AGENDA FOR REGULAR MEETING VILLAGE OF TINLEY PARK PLAN COMMISSION

July 21, 2022 – 7:00 P.M.
Council Chambers
Village Hall – 16250 S. Oak Park Avenue

PLAN COMMISSION STAFF REPORT

PLAN COMMISSION STAFF REPORT

*Upgraded Facade
North Elevation*

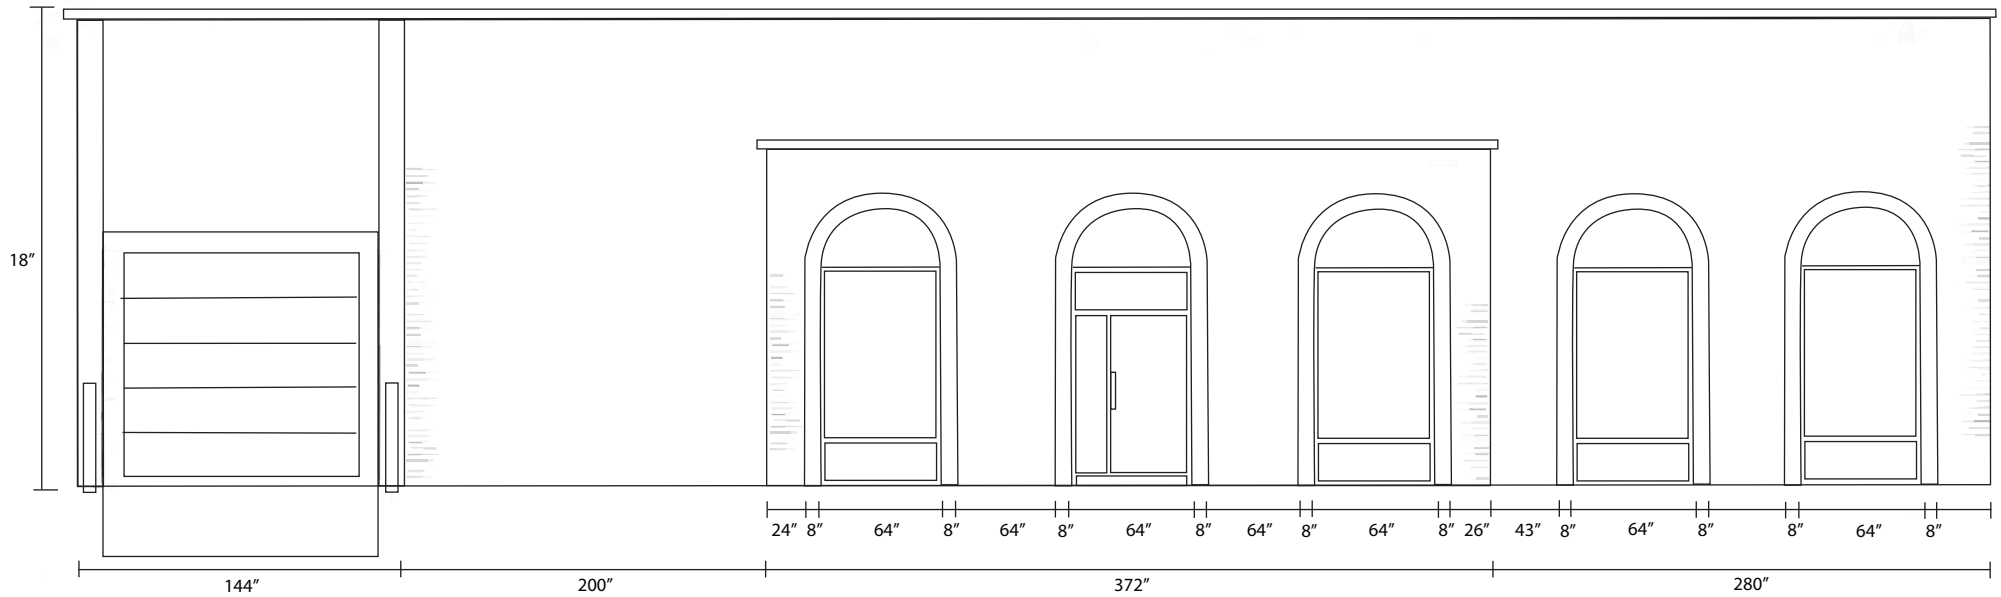
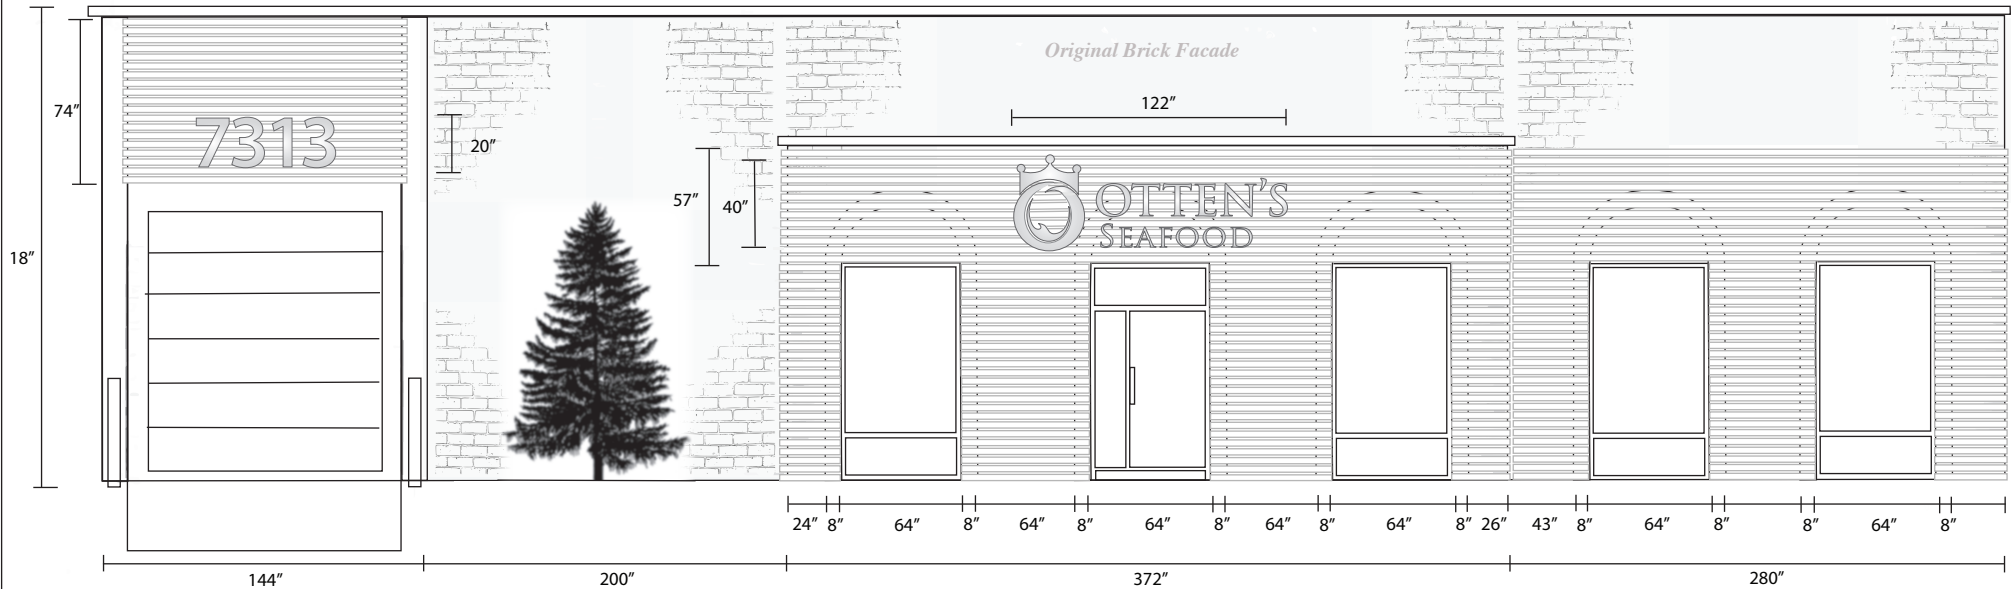
The Petitioner installed cladding consisting of wooden slats on a portion of the front façade and signage. The Petitioner states he was unaware that Variations and Site Plan/Architectural approvals were required prior to changing the façade nor did he contact the Village to see if a permit was required for such work. The Variations required are:

He notes the façade change is an aesthetic improvement to the property and the varied appearance of the Duvan Drive neighborhood, and that the wood cladding is a light, decorative treatment. He states he chose this modern and clean appearance to help keep in demands of customers in the industry. The cladding treatment is only on portions of the front façade. The cladding is dark brown 1" x 2 ½" slats secured to the building via weatherproof concrete anchors every two feet. Some of the cladding is directly attached to the brick wall. Other areas with varied relief of the brick arches have vertical wood members (2"x6"s or less) between the cladding and brick for a flat and streamlined appearance of the cladding.

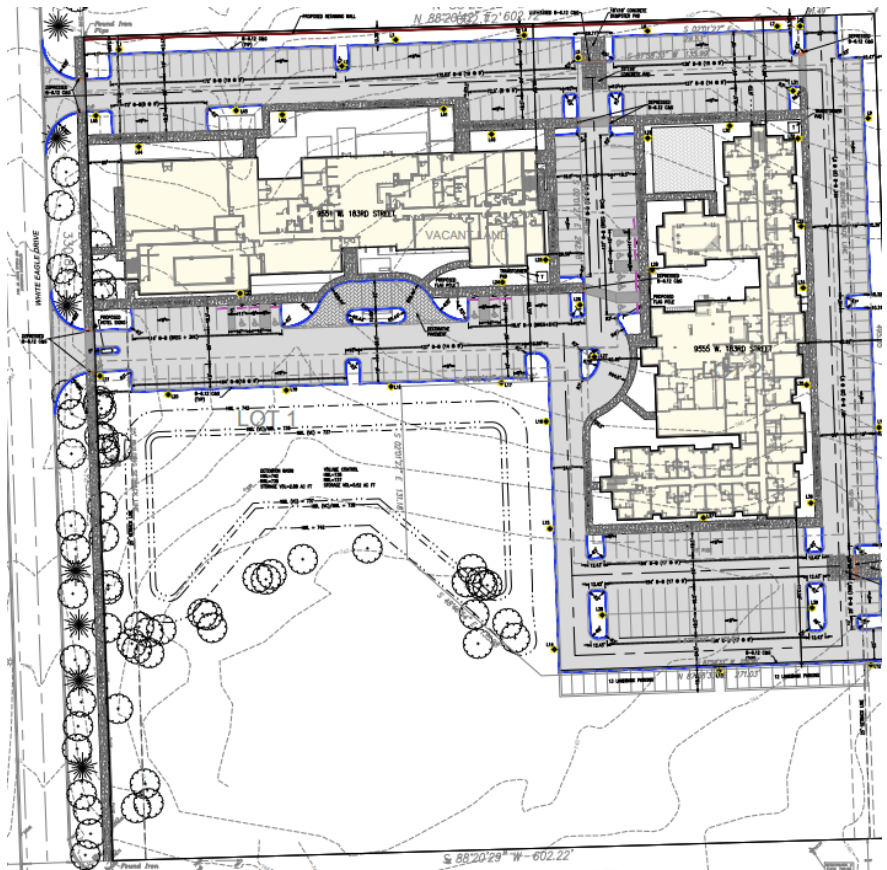
The Site Plan does not indicate specific building setbacks for each façade to the lot lines. Previously, the Plan Commission did not express concern for the proposed Variations in height due, lot size, or UDOD requirements. In the 2020 review, as requested, staff confirmed the closest residential structure (Heritage Club Villas) to the hotels will be approximately 808 ft. from the Residence Inn building.

Open Item #2: Revise plans to indicate all proposed structure setbacks.

The Petitioner provided an updated Site Plan showing all property building setbacks, with the exception of the maximum front yard setback for the Residence Inn. The Petitioner is revising the Site Plan to include this.

Table A

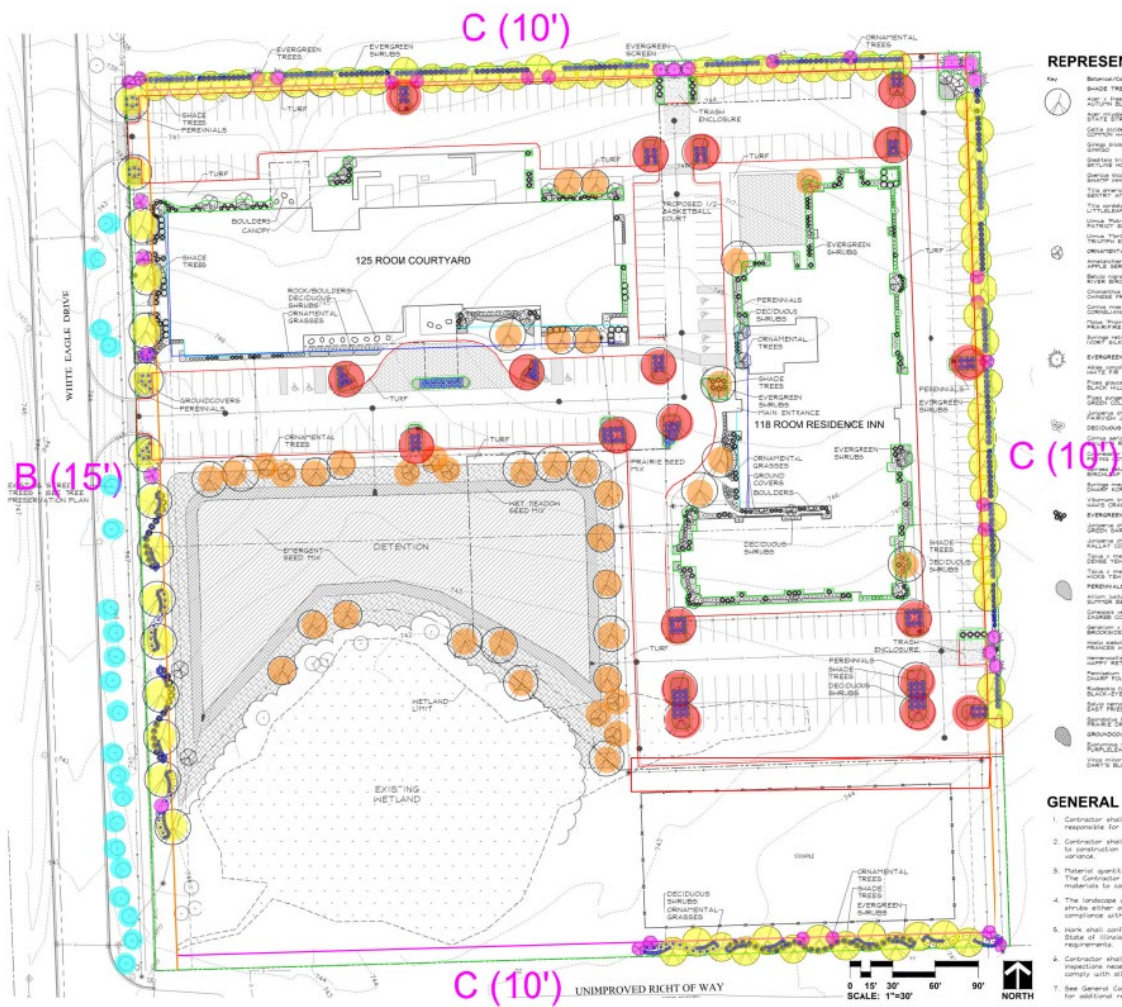
4. Add canopy trees to the two internal islands located between the hotel buildings.
5. Add shrubs around the proposed open games area.

Please review the landscape requirements noted on the previous page. Deficiencies must be addressed in a revised Landscape Plan. Please note the following abbreviations: CT = Canopy Tree, US = Understory Tree, SH = Shrub, T = Tree.

The Petitioner is revising Landscape Plans per Village staff suggestions per the Plan Commission Workshop staff report. The Petitioner has confirmed the Landscaping Plans will comply with landscape code requirements.
